# HISTORIC AND DESIGN REVIEW COMMISSION

**HDRC CASE NO:** 2017-544  
**ADDRESS:** 313 E LOCUST  
**LEGAL DESCRIPTION:** NCB 1738 BLK 3 LOT 3, EXC W 2 FT OF S 116.7 FT  
**ZONING:** C-2 H  
**CITY COUNCIL DIST.:** 1  
**DISTRICT:** Tobin Hill Historic District  
**APPLICANT:** Robert Moritz/DHR Architects  
**OWNER:** GCM Holdings, Inc  
**TYPE OF WORK:** Construction of two, 2-story duplexes  
**APPLICATION RECEIVED:** October 17, 2017  
**60-DAY REVIEW:** December 16, 2017

The applicant is requesting conceptual approval to construct two, 2-story duplex structures on the vacant lot located at 313 E Locust.

## SITE PLAN

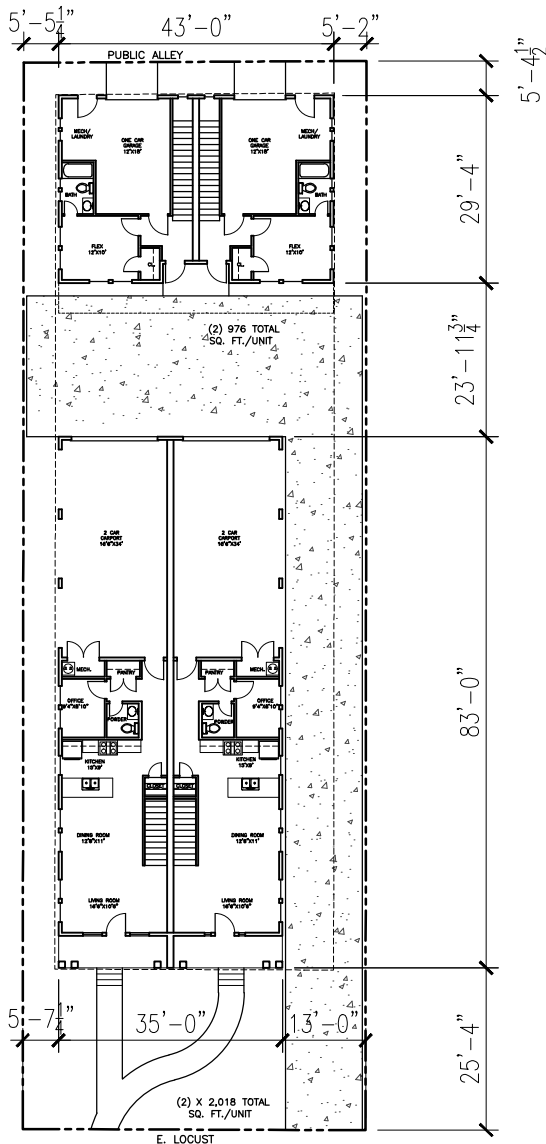
- e. **SETBACKS** – According to the Guidelines for New Construction, the front facades of new buildings are to align with front facades of adjacent buildings where a consistent setback has been established along the street frontage. This block of E Locust contains historic structures that feature front yard setbacks of approximately 20-35 feet. Based on the submitted documentation, the neighboring historic structure to the east has a front setback of 32.11 feet. The historic 1-story structure two lots down has a setback of approximately 18.24 feet. The applicant has

proposed a setback of 25'-4" inches. While the proposed setback is close to the median between those of the historic structures that exist on the same block of E Locust, its placement would be approximately seven feet closer to the sidewalk than the historic structure immediately adjacent to the east. Staff finds that the setback should be increased to be compatible with the immediate context of the block.

- l. **LOT COVERAGE** – New construction should be consistent with adjacent historic buildings in terms of the building to lot ratio. The building footprint for new construction should be no more than fifty (50) percent of the size of total lot area. The applicant has proposed to locate two units – one with a footprint of 2,905 square feet and one with a footprint of 1,230 square feet – on a lot featuring approximately 9,130 square feet. The proposed lot coverage is approximately 45.3%, which is generally consistent with the Guidelines. However, based on findings e and g, staff finds that the depth of the proposed carports should be reduced to eliminate overall mass.

- i. That the applicant increases the setback of the front unit to be more consistent with the adjacent 2-story historic structure as noted in finding e.

- ii. That the applicant eliminates at least one of the car stalls in each of the front units to reduce the overall length, massing, and footprint of the structure as noted in findings e, g, and l.

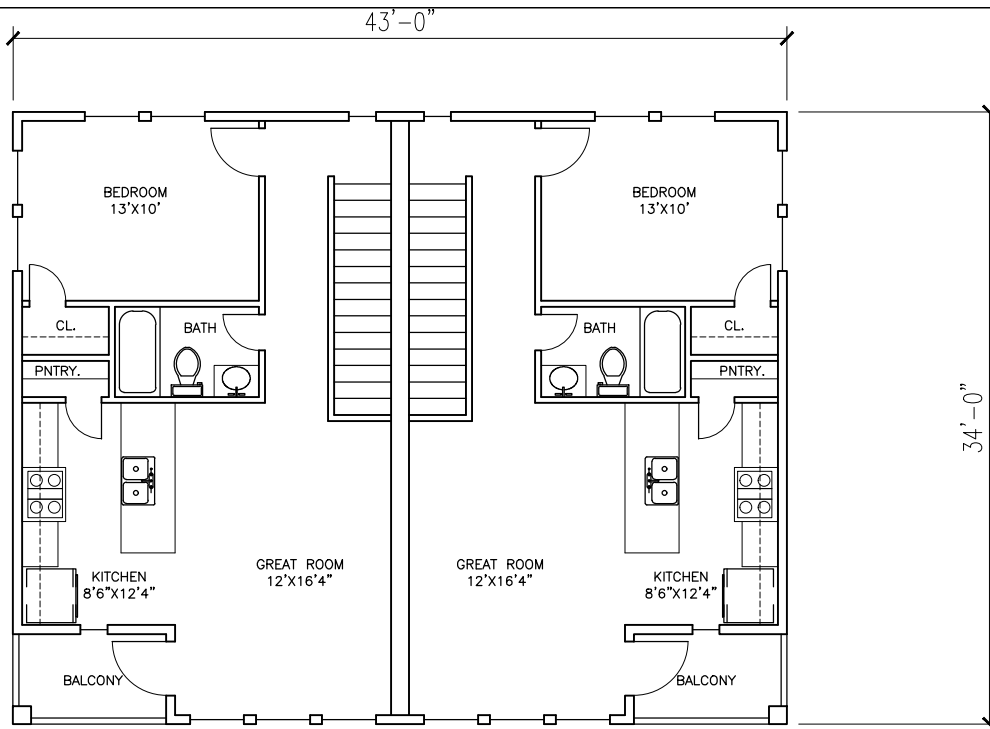
- g. **SCALE & MASS** – The applicant has proposed two 2-story units. One will be located along the street frontage of E Locust and one will be located at the rear of the property, directly adjacent to an existing alley. Per the submitted elevations, the ridgeline of the front 2-story unit is 31'-6 ¾". The ridgeline of the rear unit is 28'-10 ¾". Guideline 2.A.i stipulates that the height and scale of new construction should be consistent with nearby historic buildings and should not exceed that of the majority of historic buildings by more than one-story. Per the submitted elevations, the applicant has indicated that the 2-story historic structure directly to the east is approximately 35'-4" in height. The rear 2-story structure does not overwhelm existing alleyway structures in terms of height.

- j. **WINDOW & DOOR OPENINGS** – According to the Historic Design Guidelines for New Construction, window openings with a similar proportion of wall to window, as compared to nearby historic facades, should be incorporated. Similarity is defined by windows that are no larger than 25% in size and vary no more than 10% in height to width ratio from adjacent historic facades. The applicant has proposed several window and door openings that generally feature sizes that are found on historic structures. However, the entry doors feature transom and side lite configurations that are found historically in the district. Staff finds that the configuration should be modified to more closely match those rooted in historic precedents.

not detract from nearby historic structures. The proposed front unit features a second story gable, front entry door transoms and side lites, and simple square columns with a capital and base. The rear unit features ganged windows, bracketed eaves, and simplified columns. Staff finds these architectural details to be generally consistent with the Guidelines, but finds that the small hipped porch projections on the public alley elevation should be lowered to be closer to the top of the door frame, which is more consistent with historic duplex patterns.

- iii. That the applicant modifies the proposed entryway configurations to be more consistent with transoms and side lites found on historic precedents in the district as noted in finding j.
